January 11, 2022
7:00 PM
Planning Board Agenda

Public hearing on applications for Subdivision Approval (lot merger) and Site Plan Approval, three-story mixed-use residential and commercial development, 364 Main Street, submitted by O'Donnell Construction Corp.

Re: 364 Main Street, Beacon, New York
Site Plan Application – Responses to Comments

1st Floor Plan
Scale: 3/32" = 1'-0"

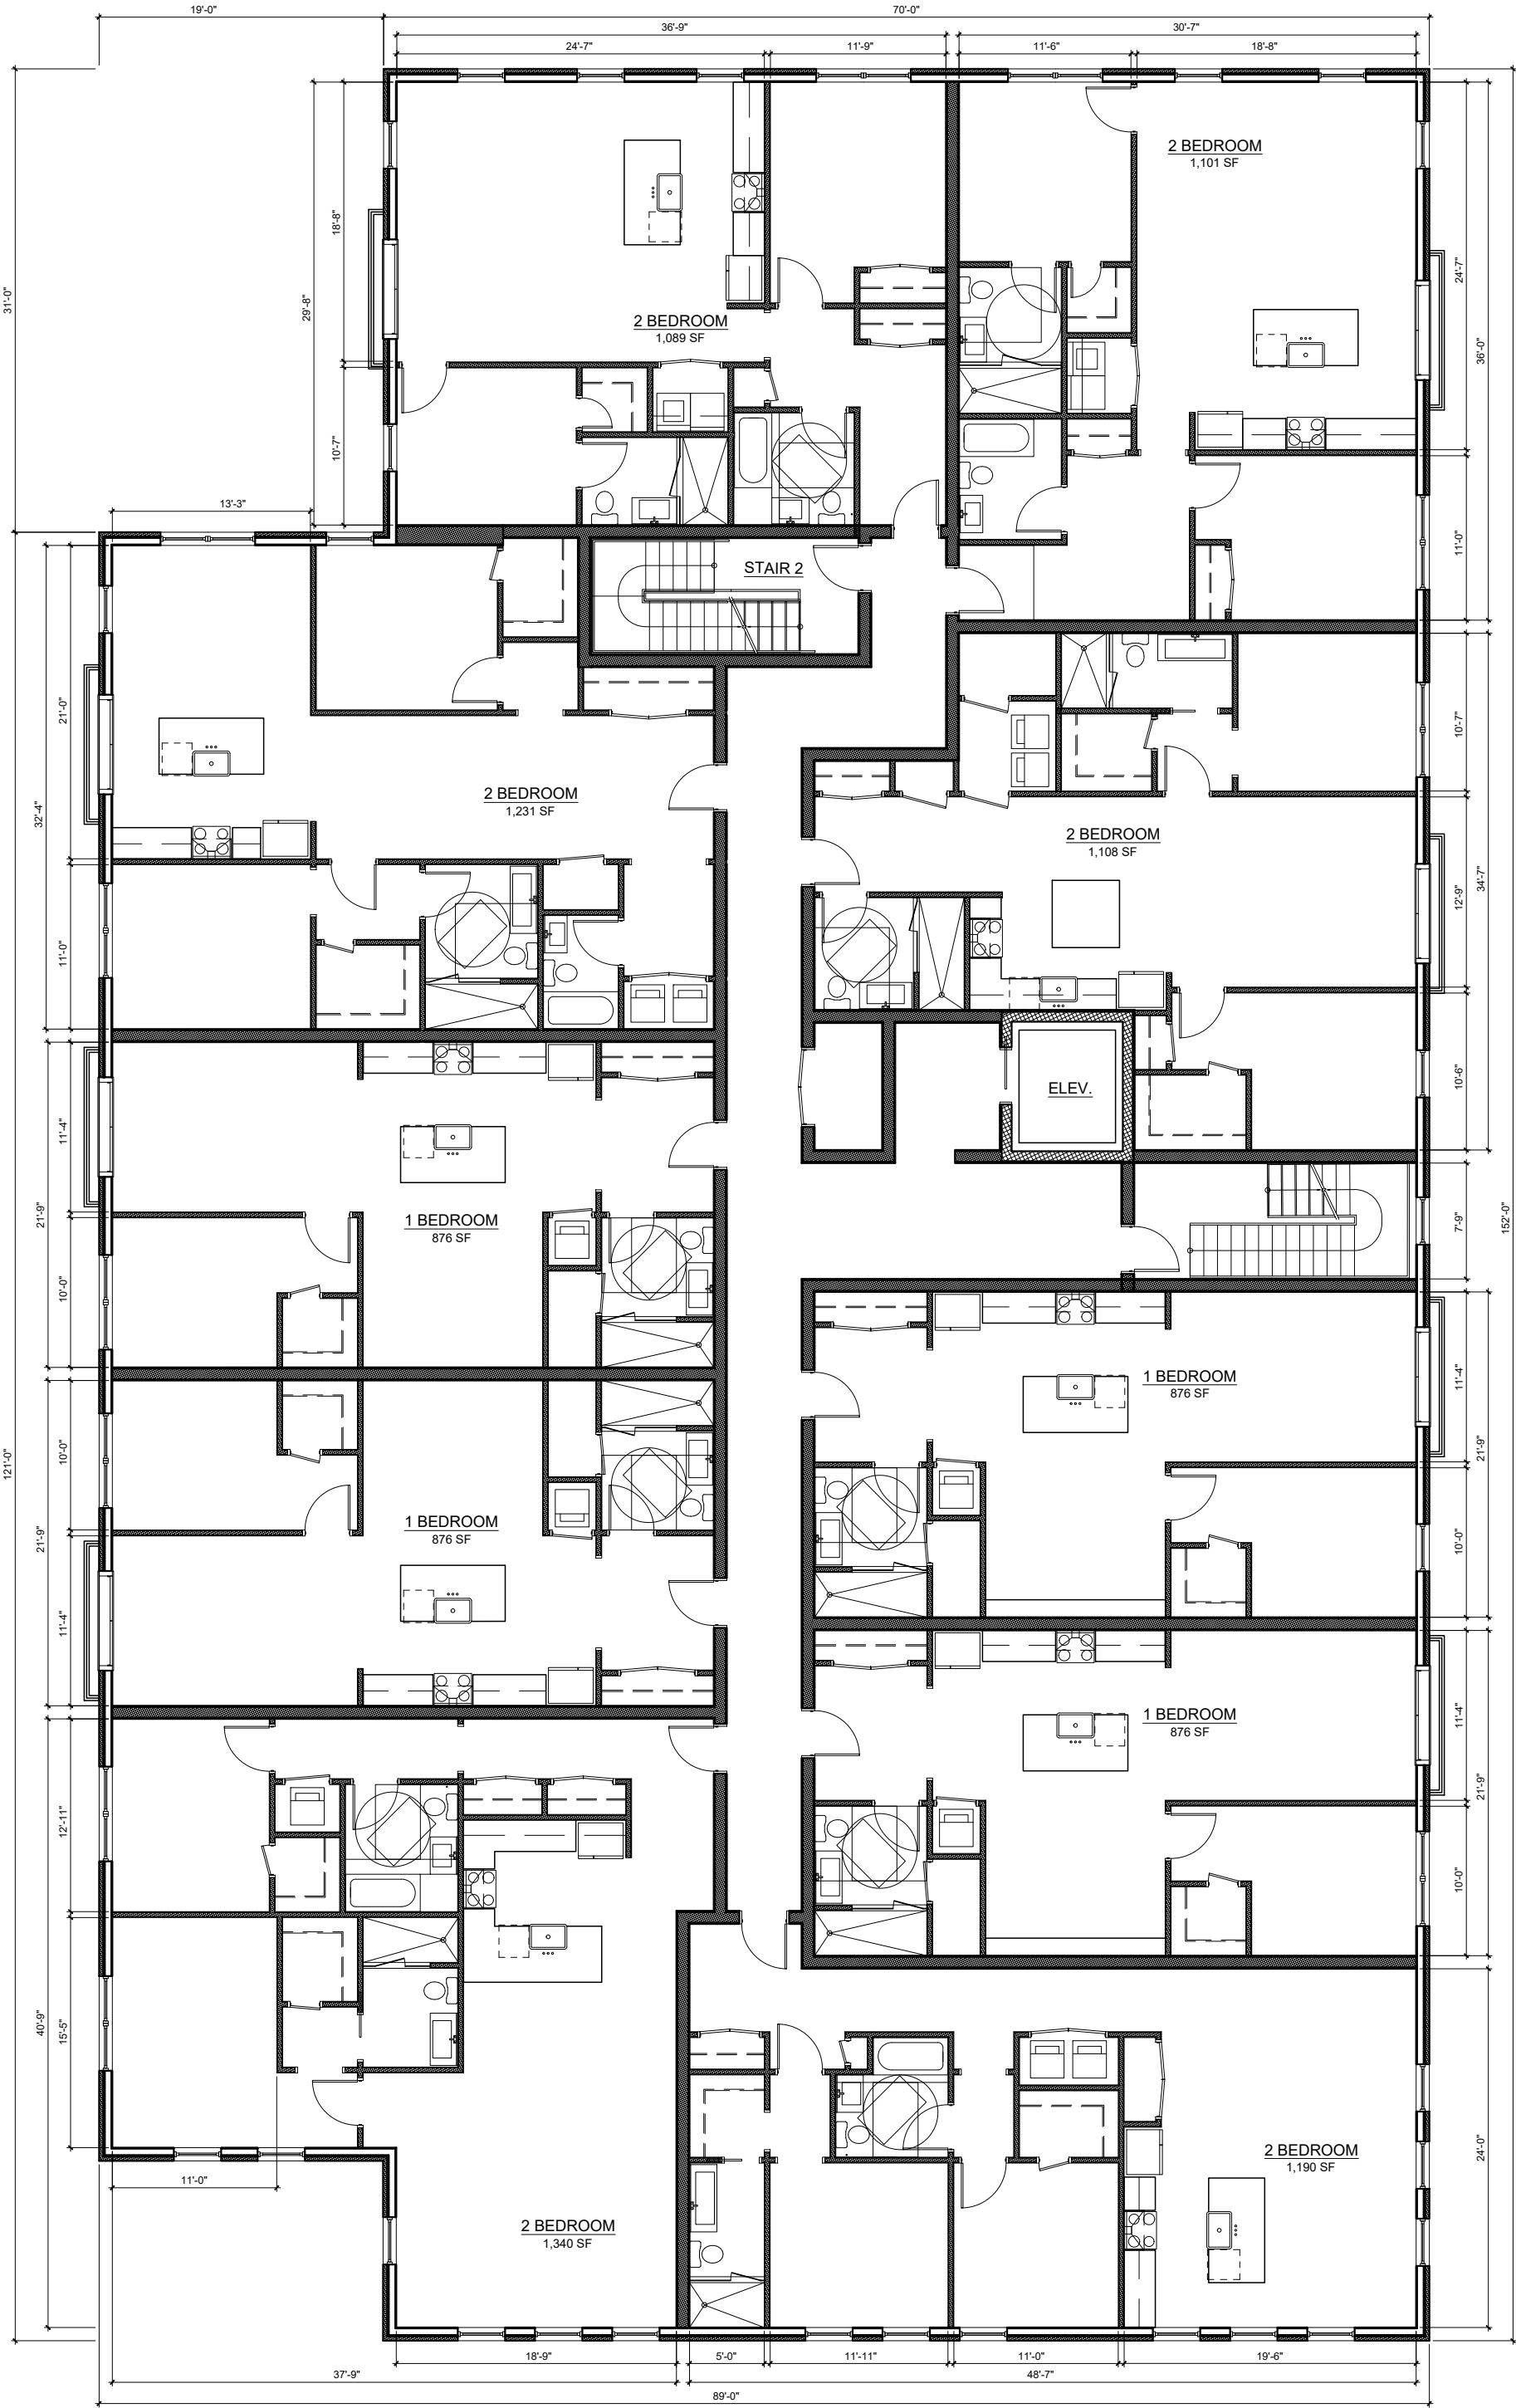
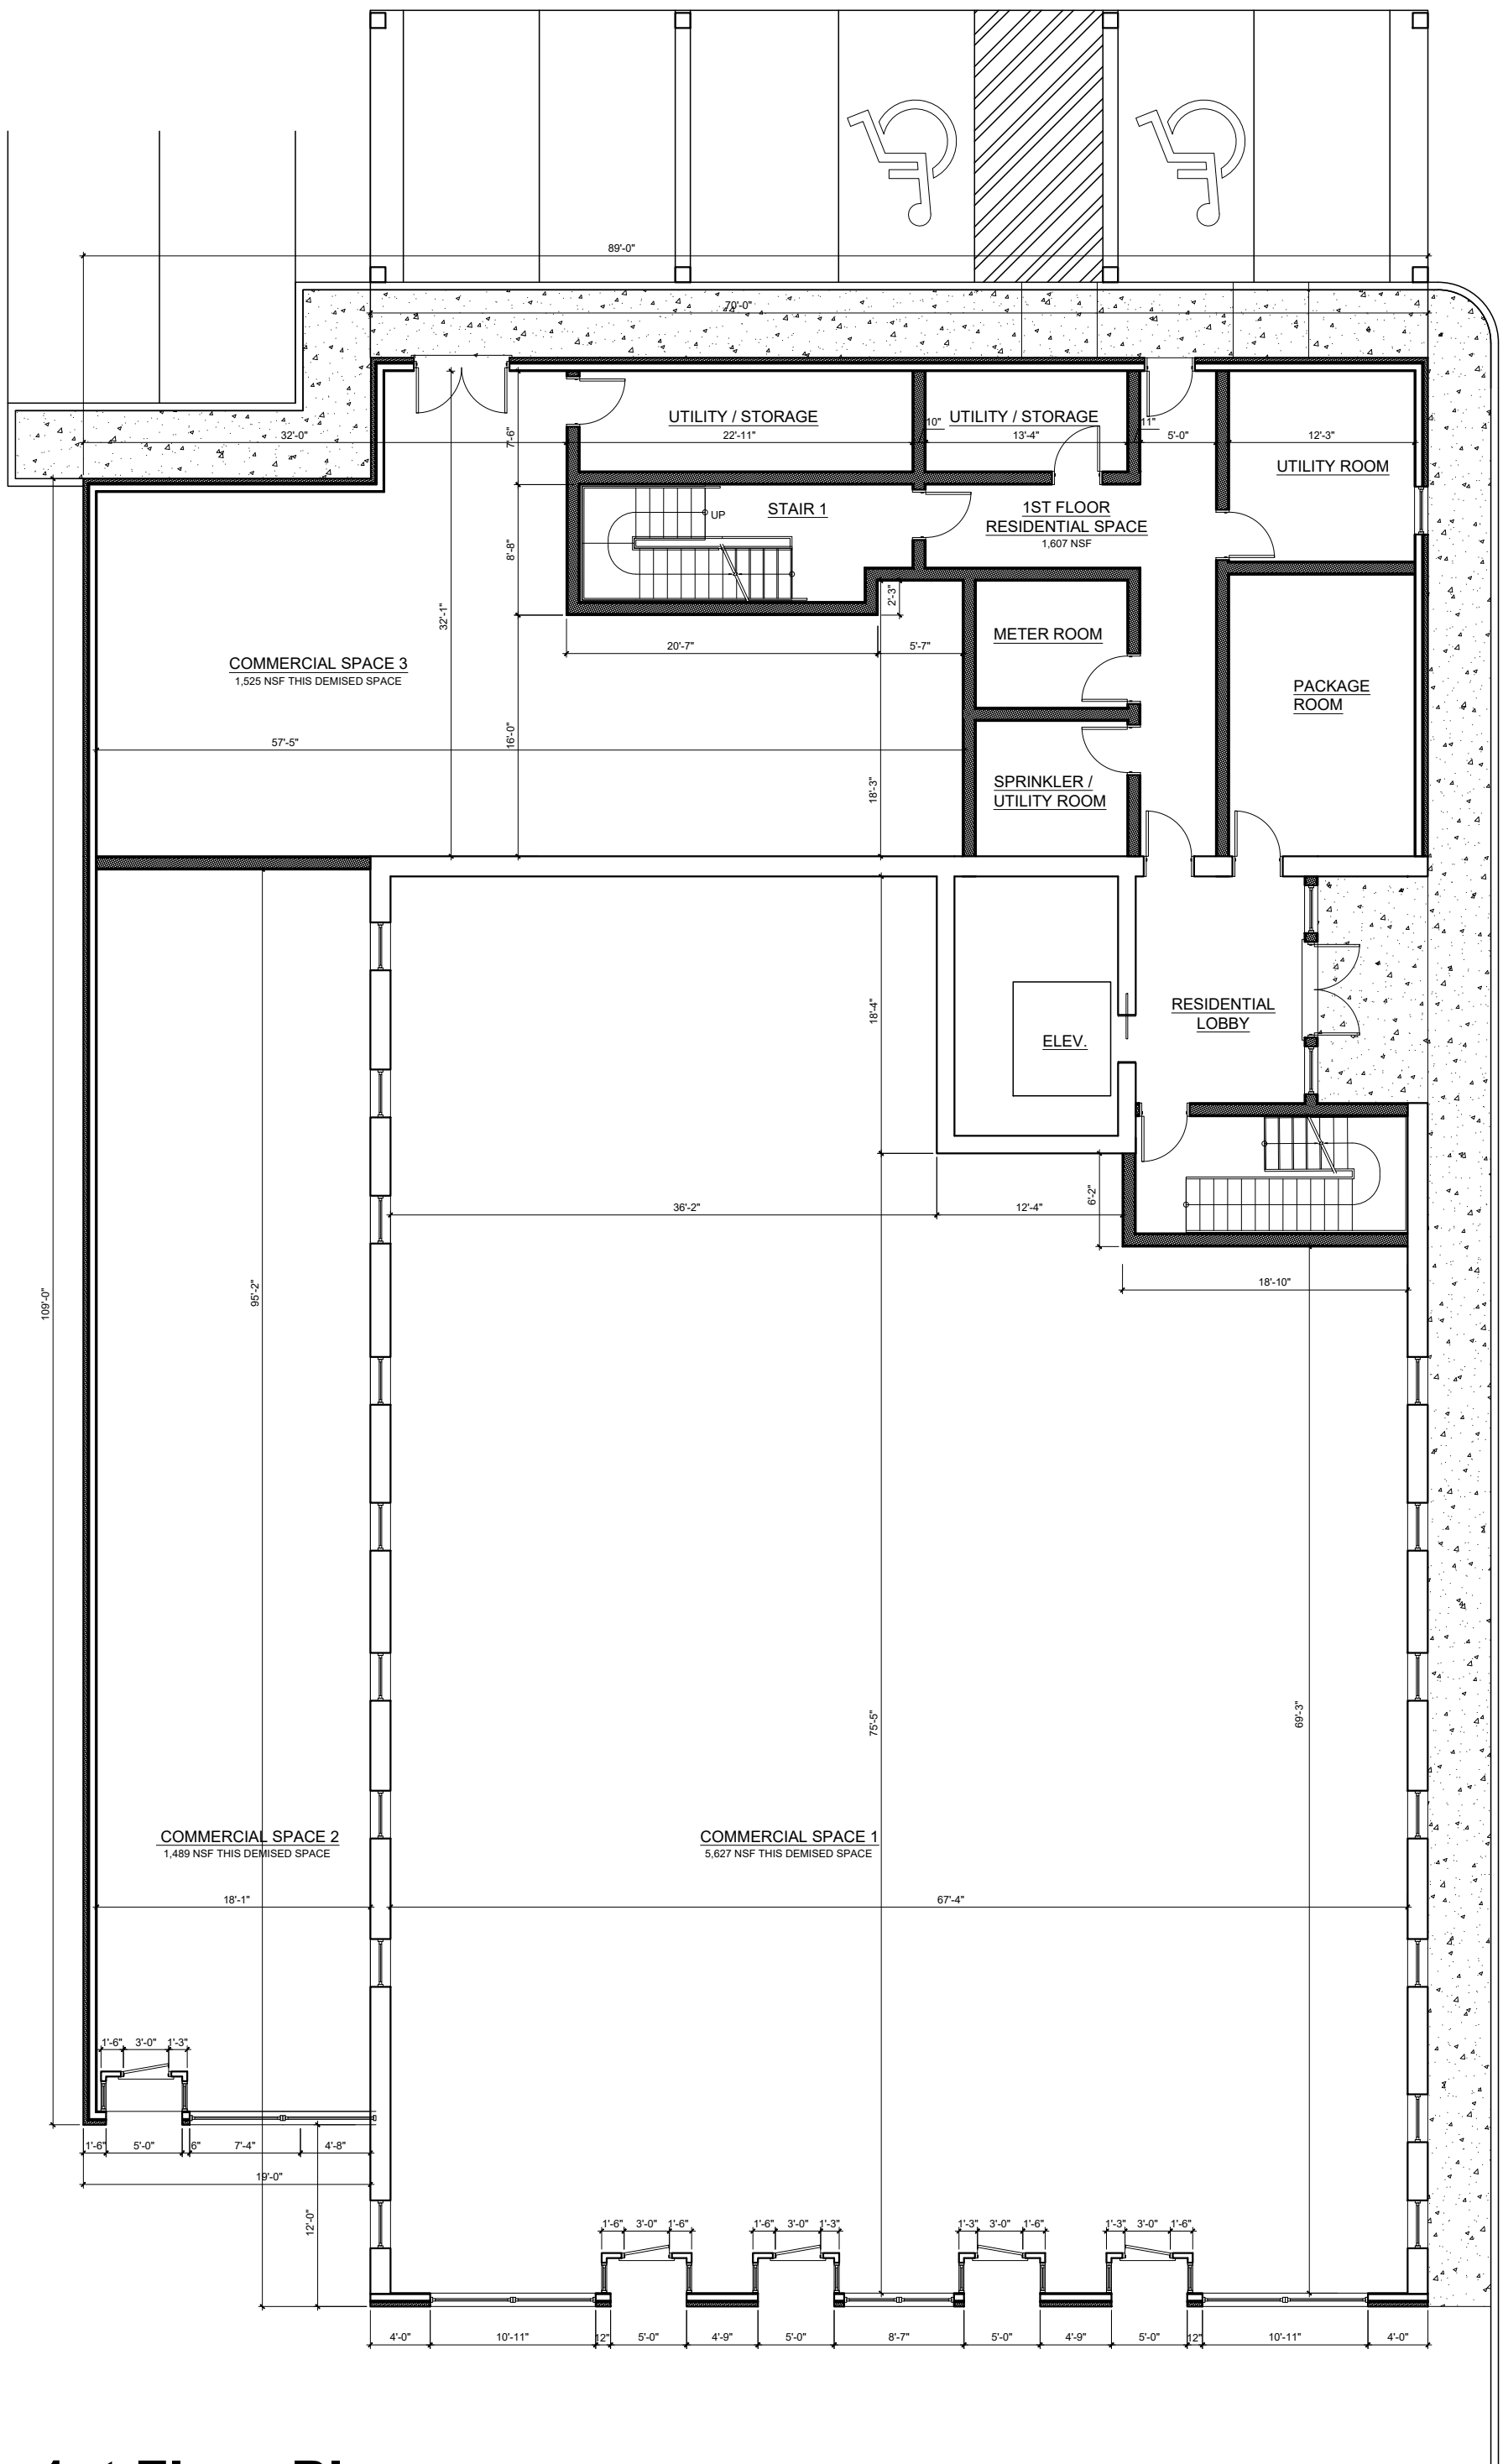
3. For the Sheet 4 and 5 Building Plans,
 - a. For the Roof Plan, the applicant and Board should consider green roof plantings, solar panels, and a tenant access area.
 - b. The mechanical equipment, stairs, and elevator bulkhead should be shown on the elevations.
4. On the Lighting Plan, the light pole on the line between two parking spaces should be relocated.
5. The printed version of the Lot Line Change sheet has an incorrect scale.

7. For Sheet 4 & 5 Building Plans
 - a The site plan has been revised to show 5 storefront entrances
 - b A roof plan will be provided in the next submission
 - c Comment acknowledged. The project will be referred to the Architectural Review Committee.
8. A lighting plan is provided in the Day & Stokoska set

1. A table has been added to this sheet that lists the floor areas
